# Central Planning Authority

**Agenda** for a meeting of the Central Planning Authority to be held on **3 January 2024 at 10:00am** in Conference Room 1038, 1st Floor, Government Administration Building, 133 Elgin Avenue

CPA/01/24

Figure 1: Land cover map of the application site (outlined in blue) (Landcover Source: DoE, 2013)

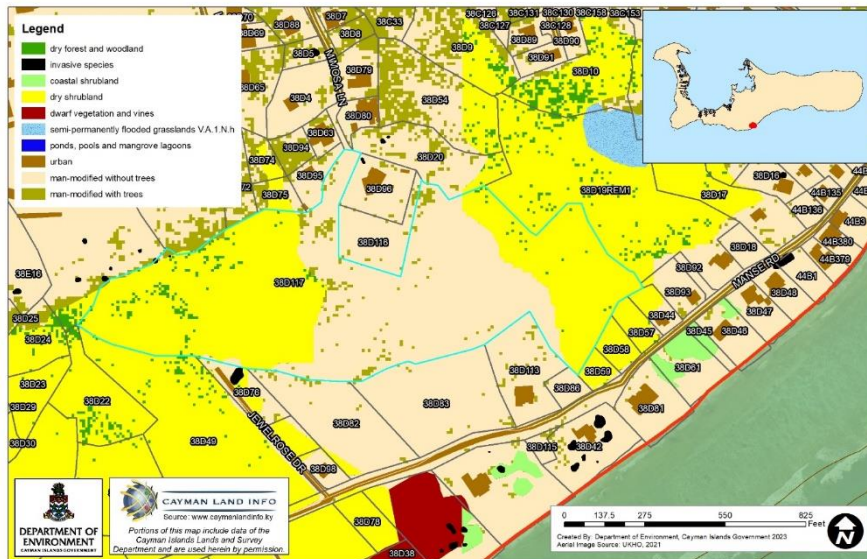
*The application site consists of approximately 50% **primary** dry shrubland with small pockets of dry forest, and approximately 50% man-modified habitat (refer to Figure 1). Primary habitat is mature habitat in its natural state, otherwise uninfluenced by human activity where ecological processes are not significantly disturbed. These habitats are often very old, existing long before humans and may consist of many endemic and ecologically important species. Primary habitat is in severe decline and becoming a scarce and highly threatened resource as a result of land conversion for human activities.*

Figure 2: Proposed subdivision layout (Source: Planning Submission Set, 2023)

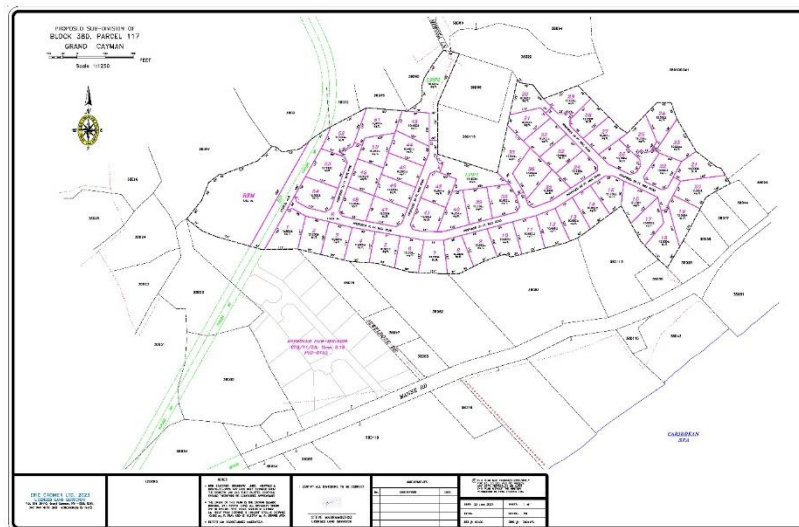
We note that the application is for a subdivision (refer to Figure 2), we would **not** support the clearing of this site at this time. Land clearing should be reserved until the development of individual lots is imminent (through the granting of planning permission for development on those particular lots). This allows the opportunity for the individual lot owners to retain as much native vegetation as possible. Clearing the entire site prematurely removes the choice from the individual lot owners and removes the value the habitat could provide in the time between the preparation of a subdivision and the development of an individual lot. In addition to this, we note that the subdivision layout includes both a Remainder parcel and two LPP parcels. The Remainder parcel is located in primary habitat, while the two LPP parcels are currently located in man-modified habitat (refer to Figure 3). The LPP parcels could be retained, without wholesale clearing, in order to continue providing valuable ecosystem services such as providing a nature-based amenity for the community. We recommend that the applicant reconsiders the layout of the subdivision such that the LPP parcels can be placed in such a way as to aid the retention of primary habitat.

1. There shall be no land clearing, excavation, filling or development of the resultant residential lots, remainder parcel and LPP parcels without planning permission for such works being granted.

Figure 2. Proposed development plans on site with the parcel boundary highlighted in red and location in reference to a Marine Protected Area (Aerial Imagery Source: UKHO, 2021).

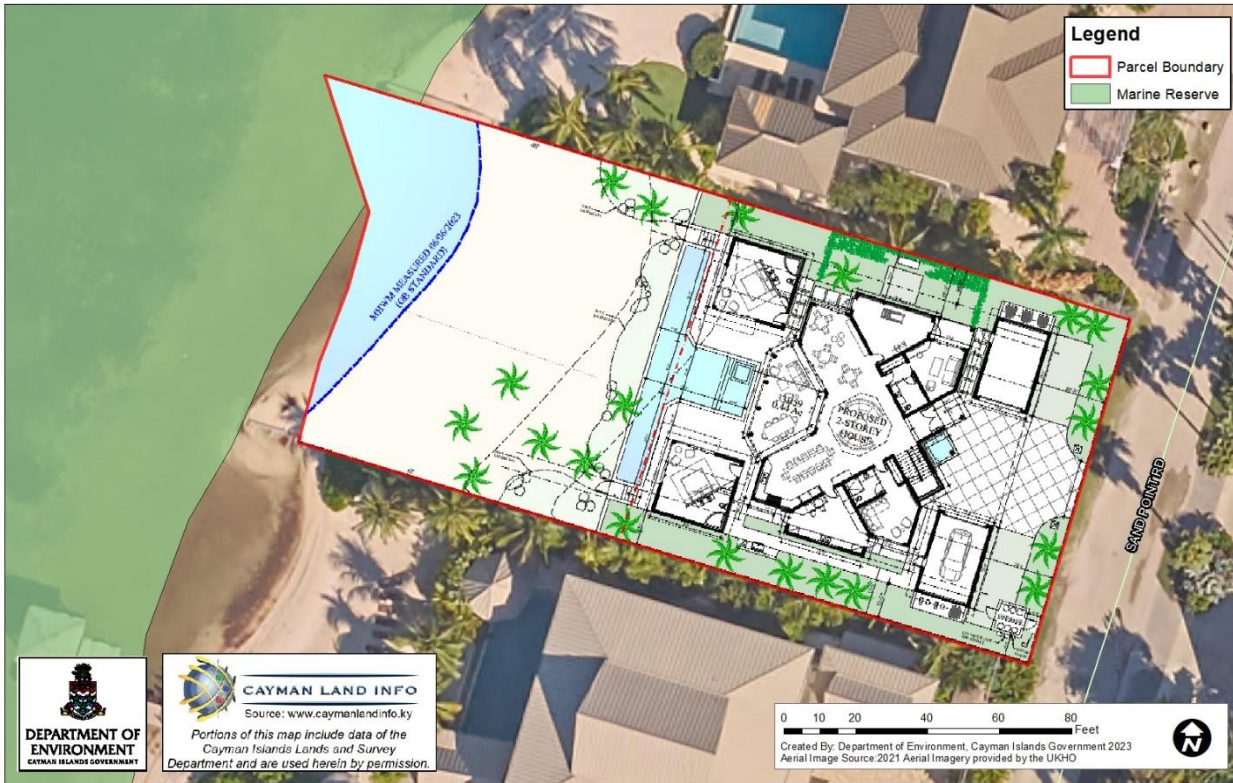
As shown in Figure 2, we note that the setback of the proposed development falls short of the minimum required setbacks from the registered Mean High Water Mark (MHW) under section 8(10)(b) of the Development and Planning Regulations (2022 Revision). We note that the proposed pool and pool deck are as close as approximately 50 feet from the MHW and the proposed house is as close as approximately 65 feet from the MHW. Neither of these structures meet the minimum 75-foot coastal setback for beaches required in the Development & Planning Regulations. The Department strongly maintains its stance that coastal setbacks should not be reduced but instead should be treated as a minimum (as prescribed in the Development & Planning Regulations). Setbacks seek to reduce the impacts of storm-related damage upon coastal infrastructure and ensure that development does not encroach onto the “active” part of a beach, as the back beach holds reserves of sand that are critical for sediment supply during periods of storm activity and erosion.

The importance of setbacks is amplified when considered within the context of climate change predictions for the region, which include sea-level rise and increased intensity of storm events (including storm surge). Inappropriately sited development (either on the active beach or too close to the MHW) reduces a beach’s potential to recover after major events. We do note that this coastline is a man-made coastline and not subject to natural replenishment cycles and coastal

The DoE is of the opinion that rebuilds, additions and modifications of developments should seek to build in a more sustainable and climate-resilient manner. For this reason, the Department does **not** support a coastal setback variance. The DoE recommends that the property is redesigned to ensure it meets the coastal setbacks. To reiterate, increasing the coastal setback increases the resilience of properties against the inevitable effects of climate change such as coastal flooding, storm surge and erosion by ensuring that hard structures are located in a way that reduces their susceptibility to these hazards.

**Image 1:** Extract of proposed site plan  
Source: Submitted application drawings

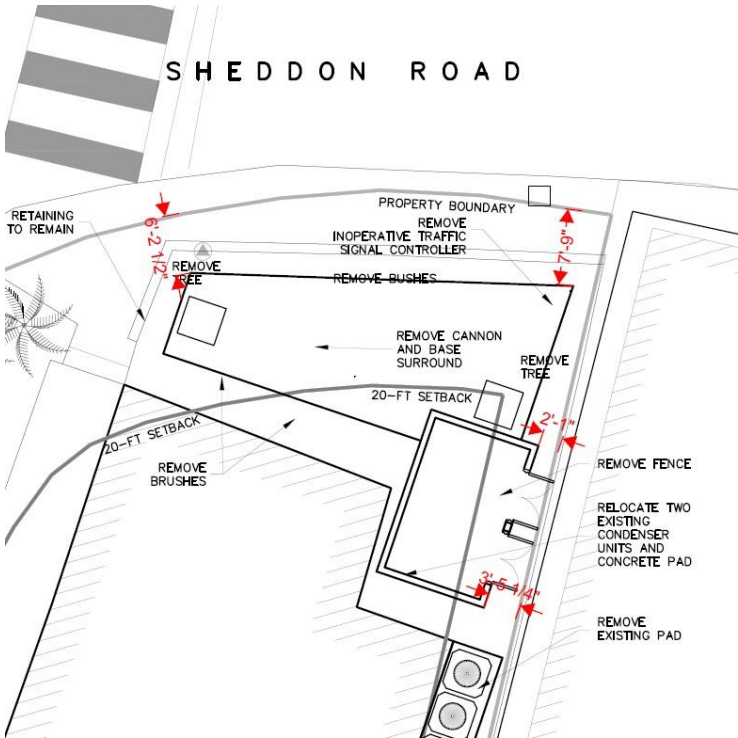
Having regard to Regulation 8(13) of the Development and Planning Regulations (revision 2022) and with respect to the submission for the installation of a cistern, fire pump room, and generator, we hereby request variances on the front and rear to allow:

- (i) Front setback for cistern: Requesting 6’ 3” vs 20’
- (ii) Rear setback for fire pump room and generator: Requesting 2’ 1” vs 6’

*The Proposed Works significantly breach the setback provisions of the Development and Planning legislation.*

*We question the realistic efficacy of the Proposed Works. They are described as part of a fire prevention system. They are obviously NOT to detect fire but to suppress it, should it break out. Whilst the area around the Museum is attractive and interesting as it reflects our heritage, it is also an elevated fire risk given the proximity of the buildings, their age and that they are all wooden. One of the first casualties of a fire in the area would be the electric supply. That could well*

*All of the buildings at that end of Sheddon Road are old and of wood. It is highly unlikely that fire appliances will be stationed so close to any fire that they themselves will be at risk, which would be the case if any appliances were positioned at the junction of Seafarers and Sheddon. An appliance would have to be positioned close to the cistern if the plan is to be able to use the stored water to fight a fire. It seems an appliance could also be more sensibly and safer positioned nearer to the Viking Gallery building and draw water from the harbour (or a fire hydrant installed at a safer distance from the old wooden buildings).*

Figure 5: Extract from the submitted plans showing the fire lane to be seaward of the proposed building expansion. We recommend the opportunity is taken to move this fire lane from the active beach profile. (Source: Submitted Plans DRG G-1)

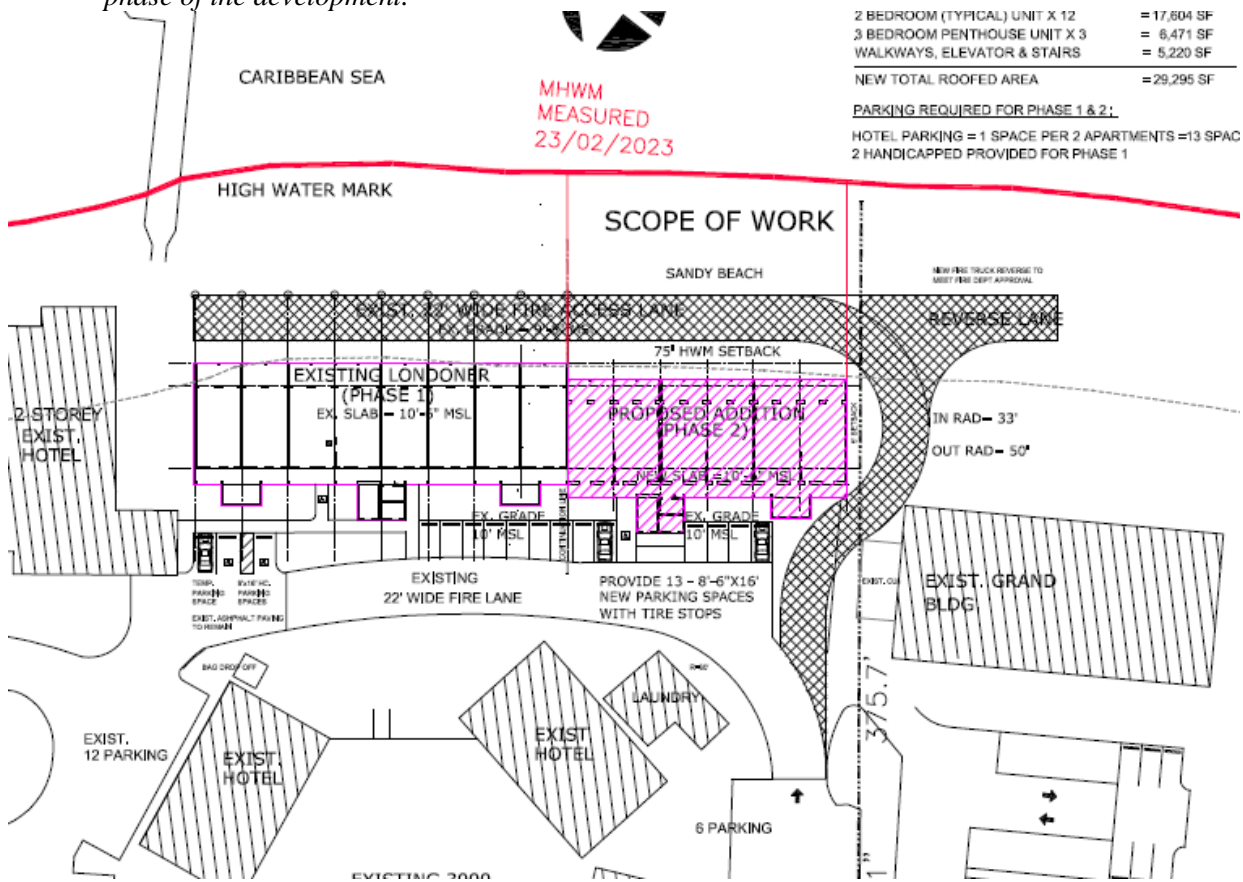
We note that the proposed plans show a fire access lane on the beach profile (refer to Figure 5), seaward of the 75' MHW setback provided by the location of the existing building on site. We recommend the necessary fire access lanes be accommodated without placing them on the active beach profile or seaward of the minimum setback, however, we note that this is a continuation of an existing firelane from a previous phase of the development.

Figure 5: Extract from the submitted plans showing the fire lane to be seaward of the proposed building expansion. We recommend the opportunity is taken to move this fire lane from the active beach profile. (Source: Submitted Plans DRG G-1)

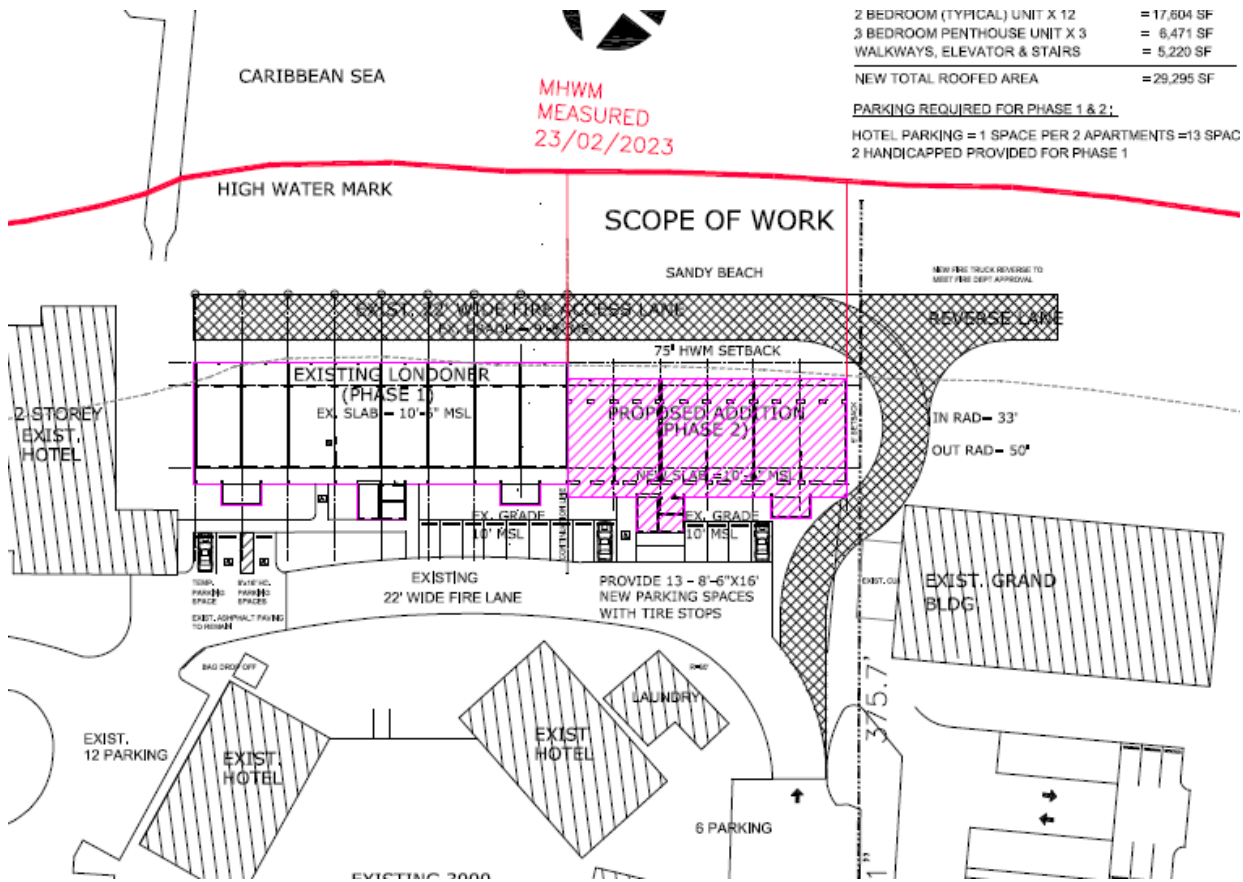
*We note that the proposed plans show a fire access lane on the beach profile (refer to Figure 5), seaward of the 75' MHWL setback provided by the location of the existing building on site. We recommend the necessary fire access lanes are accommodated without placing them on the active beach profile or seaward of the minimum setback, however, we note that this is a continuation of an existing firelane from a previous phase of the development.*

Figure 2. The application site with the parcel boundary highlighted in red and the different types of vegetation found on the site (Aerial Imagery Source: UKHO, 2021 & Vegetation Data Source: DoE, 2013).

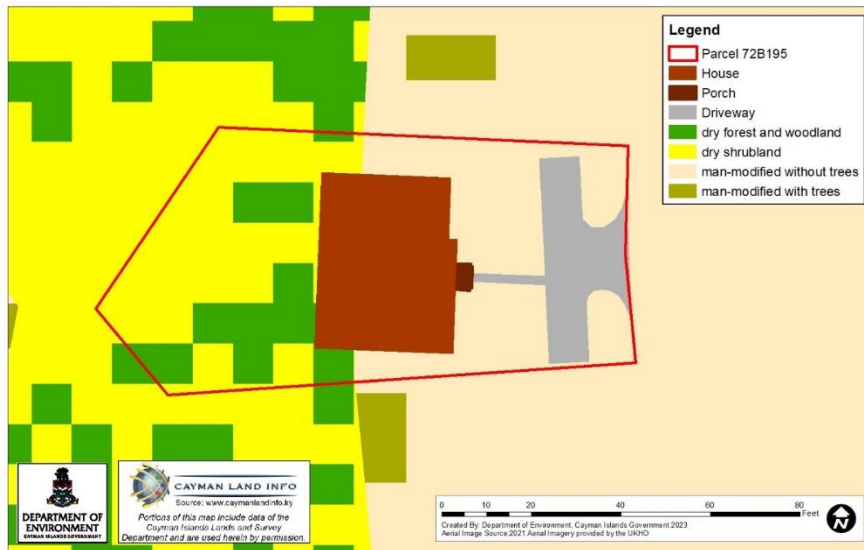
As seen in Figure 2, the applicant should retain as much native vegetation as possible and incorporate it into the landscaping scheme, particularly in the backyard area of the proposed house as it contains primary habitat. Primary habitat and native vegetation can be retained and used in a variety of ways on a property:

Figure 1: Land cover map overlaid on proposed site plan, note the majority of the site is covered by tidally flooded mangrove forest and woodland (Source: DoE, 2023)

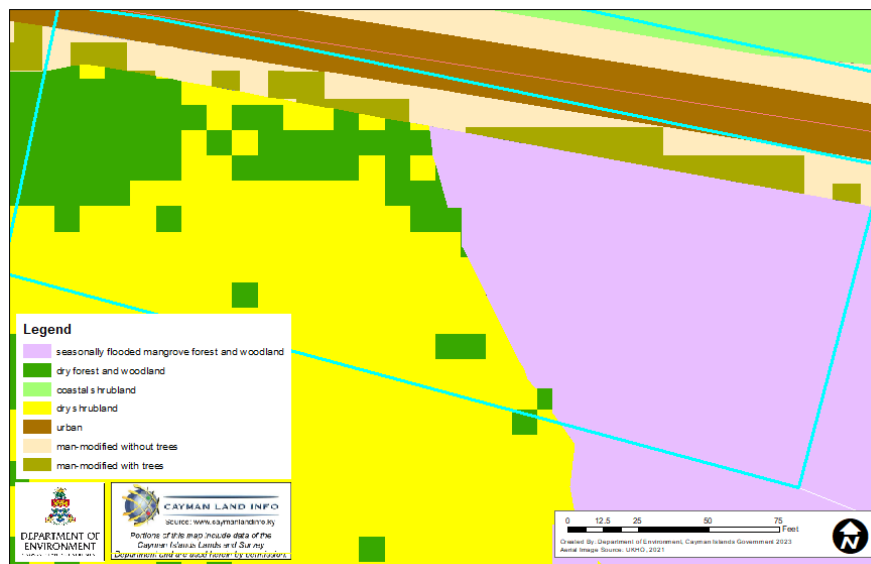
The application site consists of primary dry forest and shrubland as well as seasonally flooded mangrove forest and woodland (refer to Figure 1), although some clearing took place as a result of the implementation of planning permission for apartments north of the road by the applicant.

The proposed site plan will convert some of the seasonally flooded mangrove to hard standing. As such, drainage is likely to be a concern. The proposed site plan also features a large amount of hardscaping. We recommend that the applicant considers the use of porous or permeable paved surfaces in areas of hard standing such as the driveways and
